APDES INSPECTION REPORT

Alaska Department of Environmental Conservation

PHOTO ADDENDUM – KENSINGTON MINE

PHOTO 7: PH METER LOG

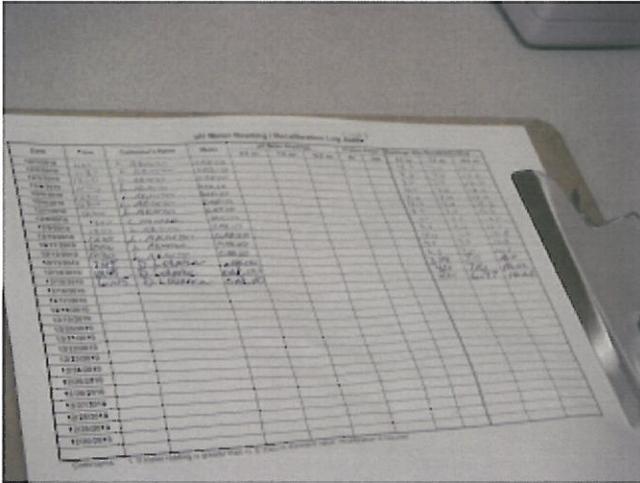
Next, we proceeded to the sampling shack. Mr. Eppers explained that the sample collection location was changed when the MWTP was expanded. One sample is collected then split into 3 sub-samples for analysis. Sampling is conducted after treatment is complete, mixing the old plant effluent and the expansion effluent. We discussed sampling procedures and reviewed calibration logs (Photo 7) for the continuous monitoring pH and turbidity meters. We checked expiration dates for pH buffer solutions (Photo 8) and observed that the 10.01 +/- .02 blue Hach manufactured solution was expired. Other buffer solutions were current.

Expired pH buffer standards were observed onsite. The use of expired standards for calibration purposes is in conflict with Part B6.2 of the QAP (Appendix 1), which states that expired standards are never used for calibration or calibration check procedures.

1. Ensure stormwater discharges are not impacted by uncovered or uncontained chemicals storage containers
2. Provide a detailed explanation of maintenance plans or procedures specific to Pond 1
3. Update QAP to ensure expired standards are unavailable for use
